Airways New Zealand Gisborne Airspace Amend Design Notes DRAFT v4 3 October 2019

This paper explains and defines the Airways version 4 requested changes to Gisborne airspace.

This version 4 differs from the earlier submitted version 2 with a small expansion of the requested 2500 ft CTA to the south of Gisborne. This is to facilitate a change to one of the planned new PBN arrival procedures.

Diagram 13 DRAFT amended GS CTA to the south of Gisborne with the protection area (the black dotted line) for the holding pattern at COOKS depicted. This diagram includes a small portion of the Airways draft change to the NR CTA LL 2500 ft.

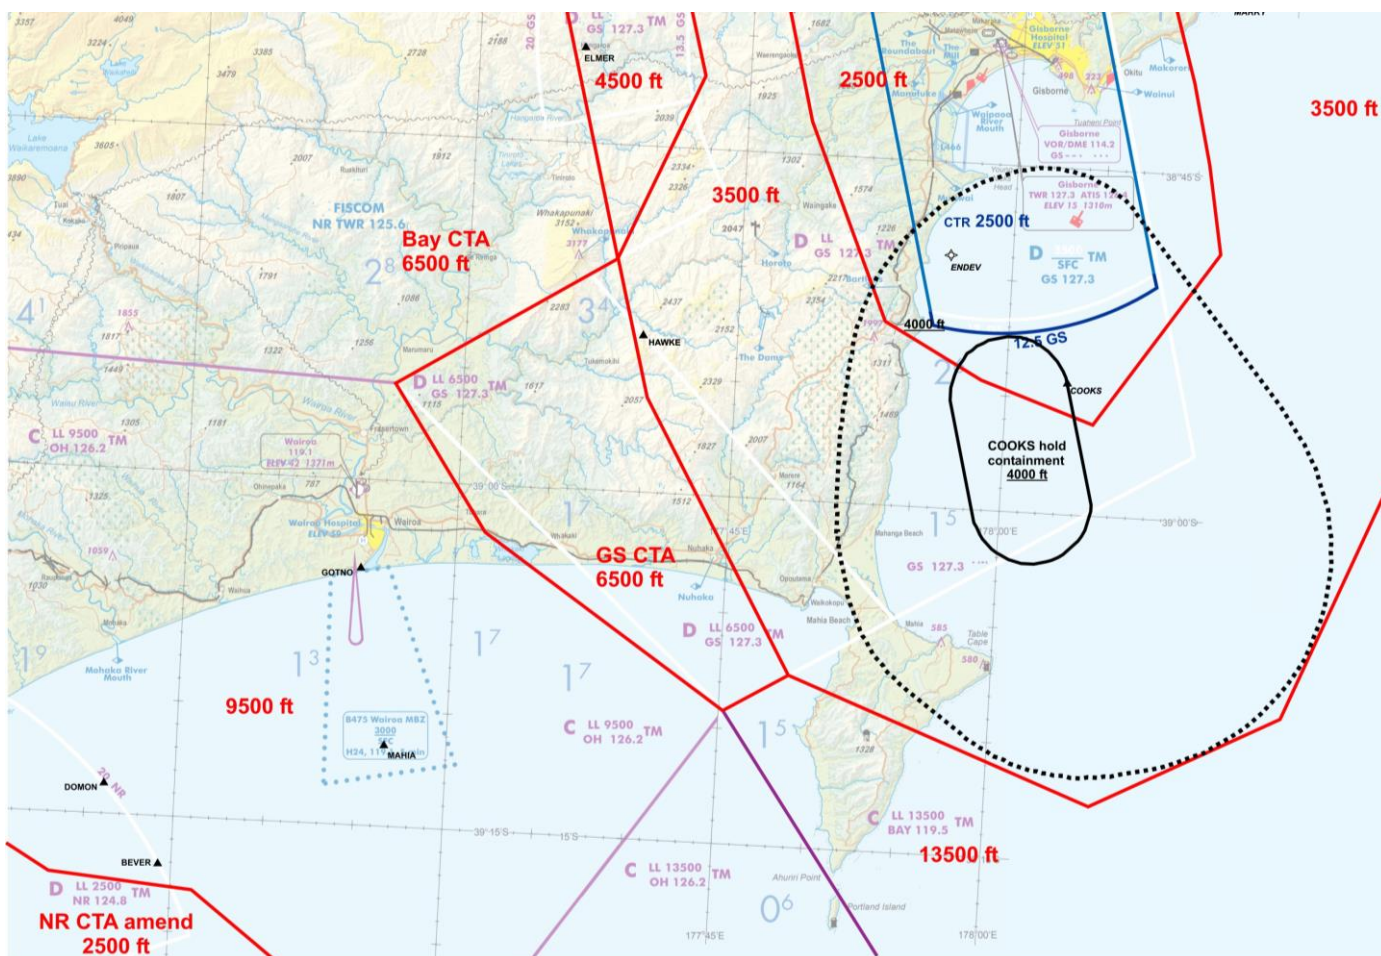
Diagram 13 below depicts the protection area for the COOKS hold. The 3500 ft CTA is expanded south to contain that protection area.

The COOKS hold would be contained at 4000 ft and above.

Diagram 14 DRAFT amended GS CTA to the south of Gisborne showing the new PBN departures off RWY 14 to the south-west.

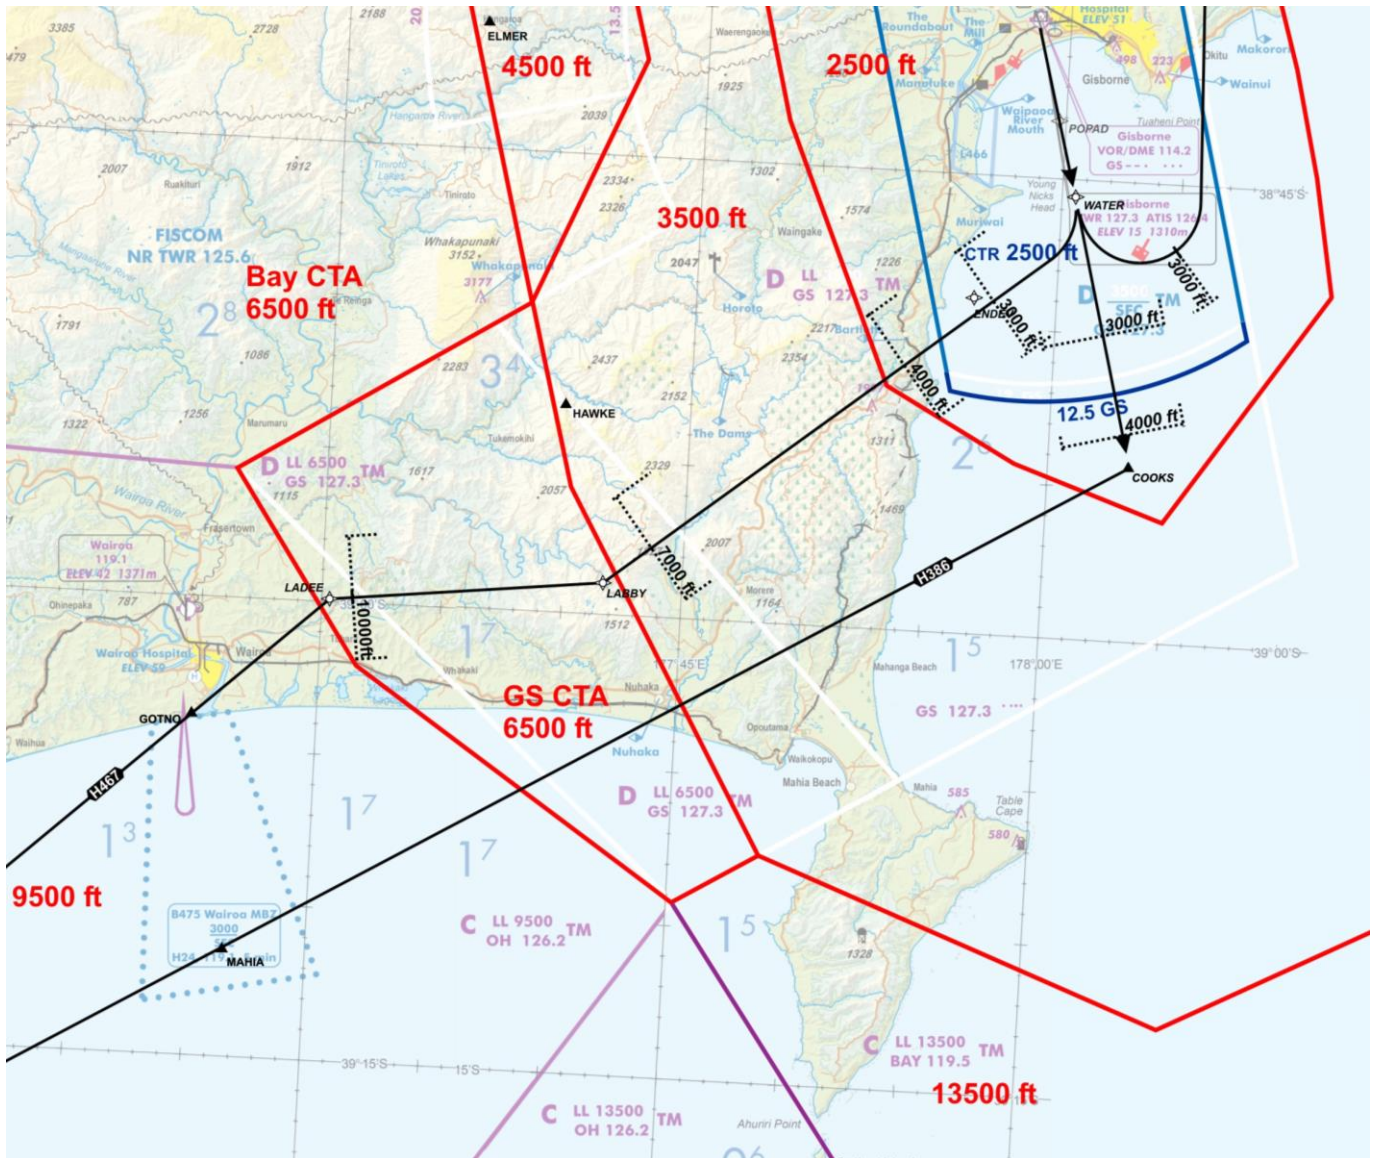
The new PBN departure from RWY 14 to the south-west determines the 2500 ft CTA and 3500 ft CTA boundaries as shown in Diagram 14 below. This departure is also the reason for the small expansion of the 6500 ft CTA east of Wairoa.

Diagram 15 DRAFT amended GS CTA to the south-west of Gisborne with the planned new PBN arrivals and RNAV approach to RWY 32. Also depicted is the new missed approach holding pattern at MARKY along with its protection area (the black dotted line) that needs containment by the 3500 ft CTA.

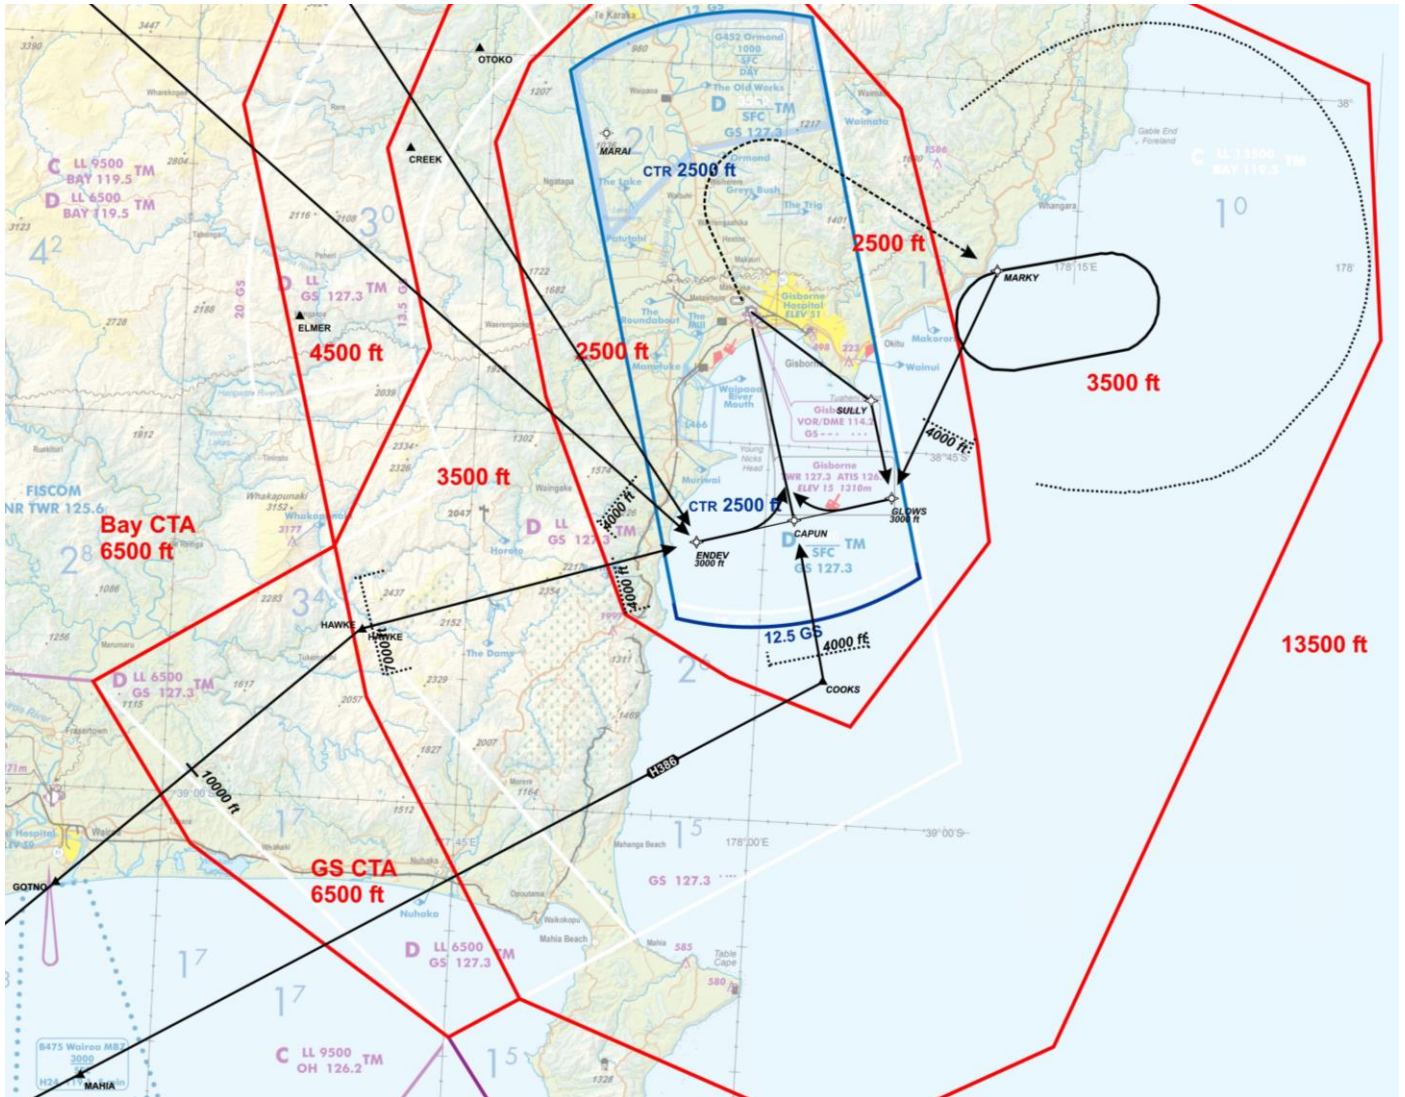
The planned new PBN arrival to RWY 32 is significant in determining the location of the 2500 ft CTA and the 3500 ft CTA boundaries as shown in Diagram 15 below.

Containment of the protection area for the new missed approach holding pattern at MARKY to the east of NZGS is the reason for the significant expansion of 3500 ft CTA to the east.

Holding at MARKY needs to be at 4000 ft or above for airspace containment.

Diagram 17 DRAFT amended airspace above 9500 ft.

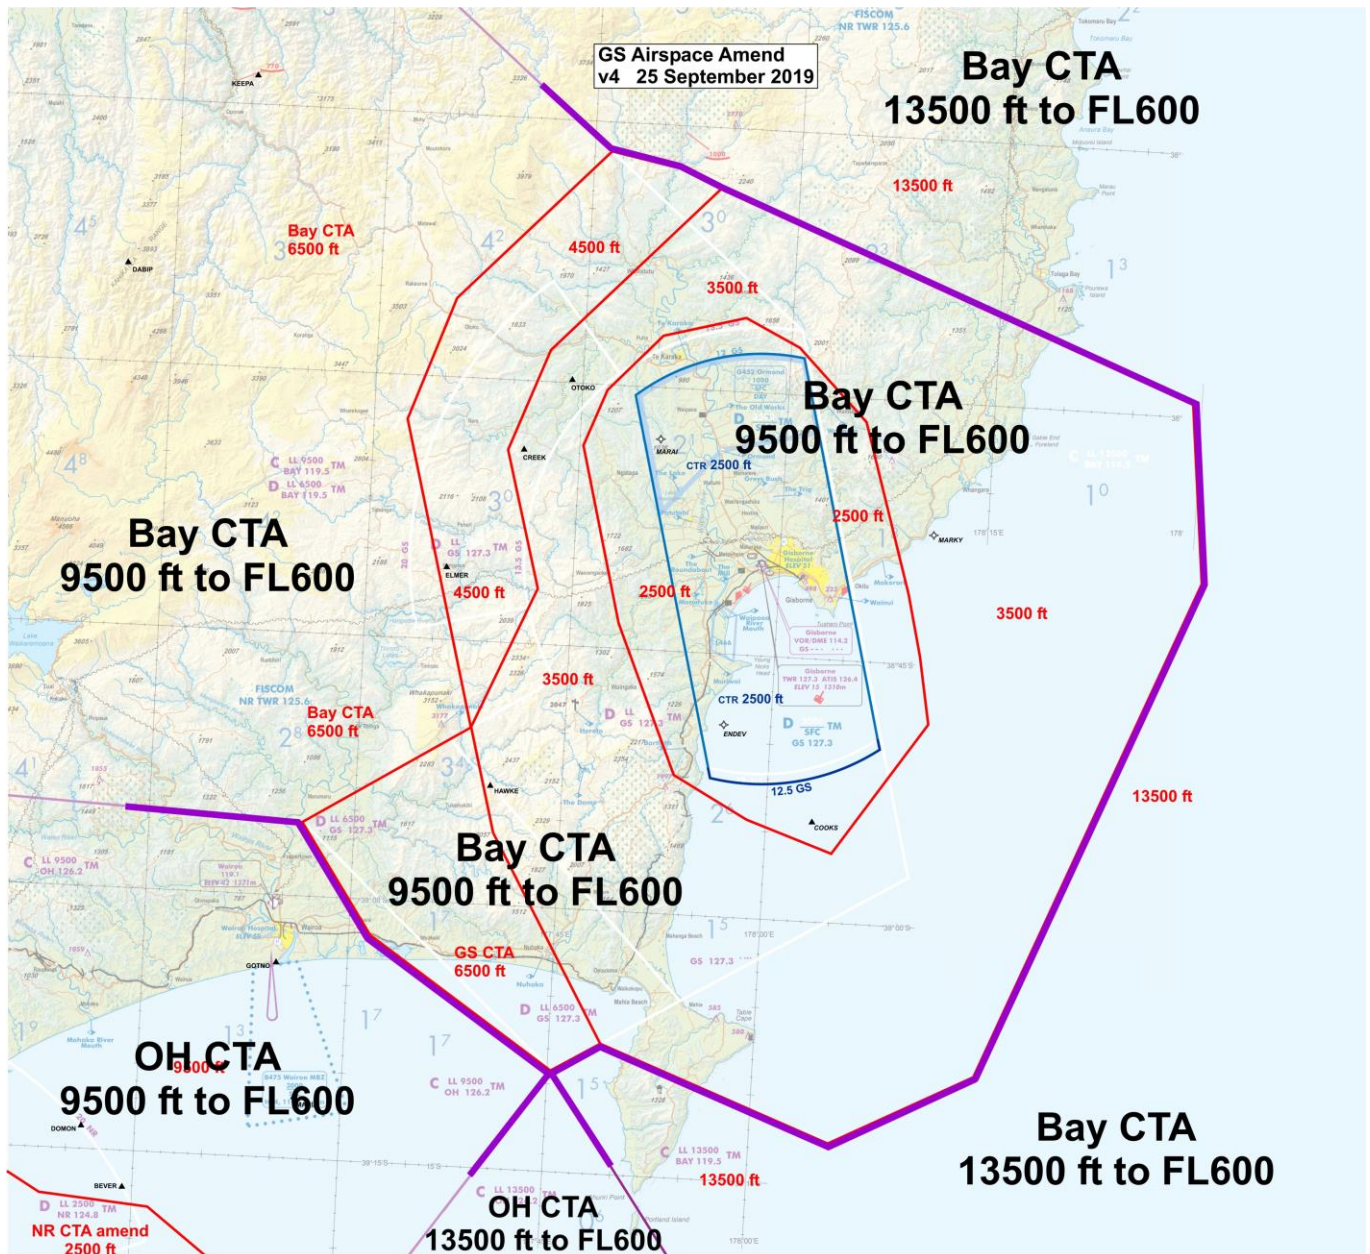
The Bay CTA LL 9500 ft that extends over the top of the GS CTA needs to be expanded to match the expanded GS CTA.

Consequently, the adjoining Bay CTA LL 13500 ft and the Ohakea CTA LL 9500 ft also need to have their boundaries modified to match the expanded Bay CTA.
